FIELD CHANGE ORDER

Issued by : DMC Hamburg Reference No. 00 135 009 Released : G. Kramm Date May 1999 **Publication No.**: 4512 980 57791 **Product Group** 742

OPTIMUS 50 RAD / RF

Electric shock during service activities in the generator cabinet.

4512 104 91421 Service kit protection cap

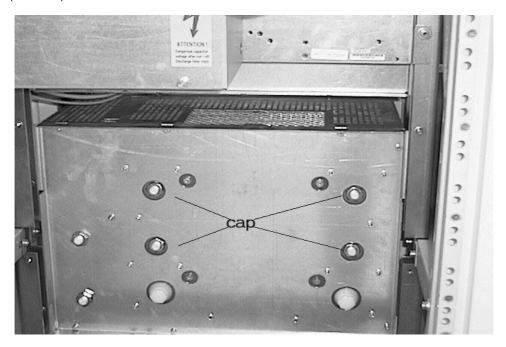
Cause : In the new 7E converter unit 9890 000 0277x, the nuts to fix the capacitors of the

intermediate circuit are not made of insulation material. The fixing nuts of the

smoothing capacitors are at intermediate circuit voltage level.

Remedy : To protect the field engineer from electric shock, the metal nuts must be covered

with plastic caps.

- Switch the generator off. Wait until the smoothing capacitors are discharged, at least 1 minute after switch off.
- Pull the generator cabinet away from wall.
- Press the protection plastic caps onto the metal nuts (see foto)
